REVISED STAFF REPORT AND RECOMMENDATION TO THE DESIGN COMMISSION

CASE FILE: LU 15-116838 DZM
PC # 14-228796
Modera Belmont
REVIEW BY: Design Commission
WHEN: July 9, 2015 at 1:30 PM
WHERE: 1900 SW Fourth Ave., Room 2500A
Portland, OR 97201

The applicant seeks a Design Review approval for a new 6-story mixed use development with 200 dwelling units and 11,468 SF of commercial space in the Central Eastside sub

LANDSCAPE COURTYARD PLAN C16

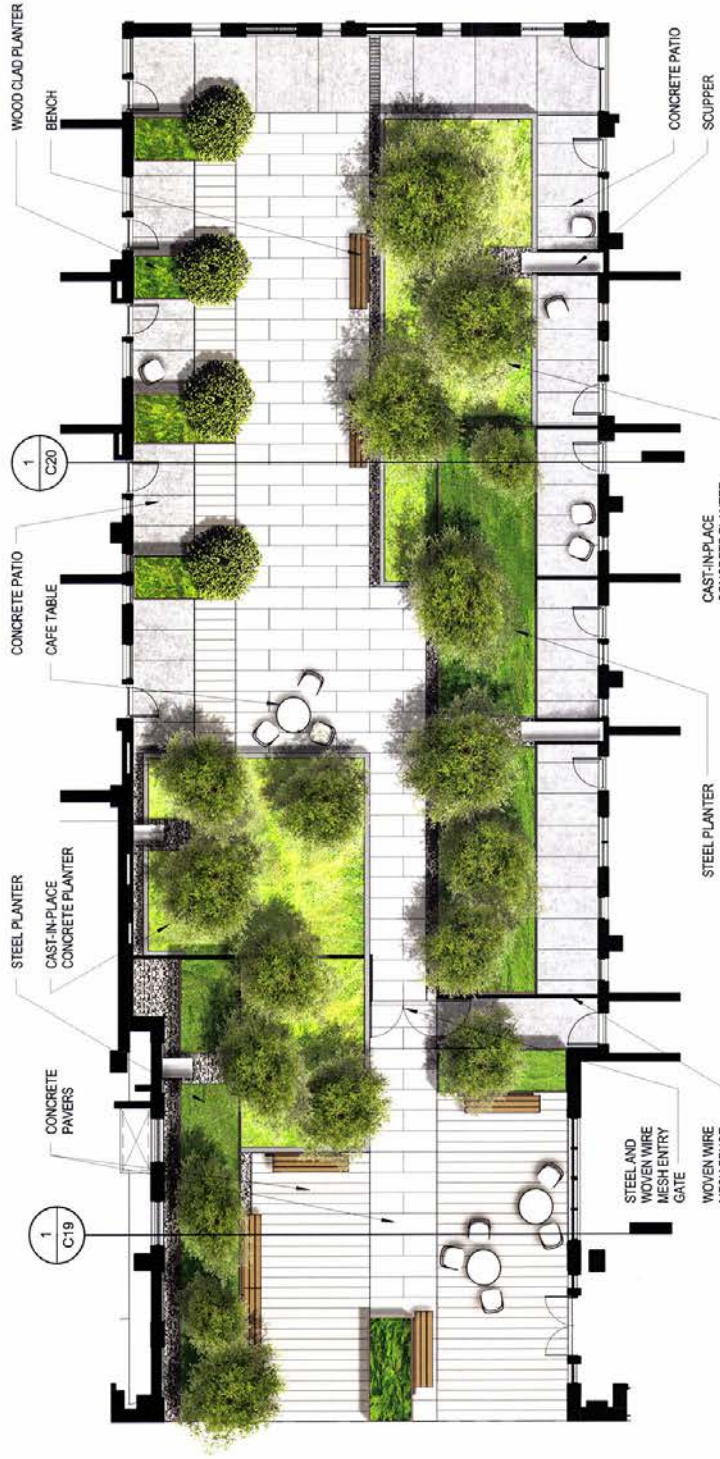
At both the DAR hearing on February 5, 2015 and the first Design Review hearing on May 6, 2015, the Design Commission stated concerns regarding the quality of the courtyard space. A wider courtyard with more gracious, usable space and a focus on improving the transition area from the public sidewalk and garage entry to the private portion were recommended. In response to these initial comments the width of private (eastern) portion increased by 3'-0", some planters were removed and re-arranged and a canopy was added at the eastern end near the entry.

At the June 4, 2015 hearing, the Commission stated that additional focus was needed at the west end of the courtyard to improve the transition from SE 6th and better activate the edge. As a result, the residential unit on the ground floor that fronts 6th and the courtyard was converted to a retail space. The raised planter along the north-facing wall in the courtyard was removed to allow for outdoor seating or spill out activity from the retail space. *As revised, these guidelines have been met.*
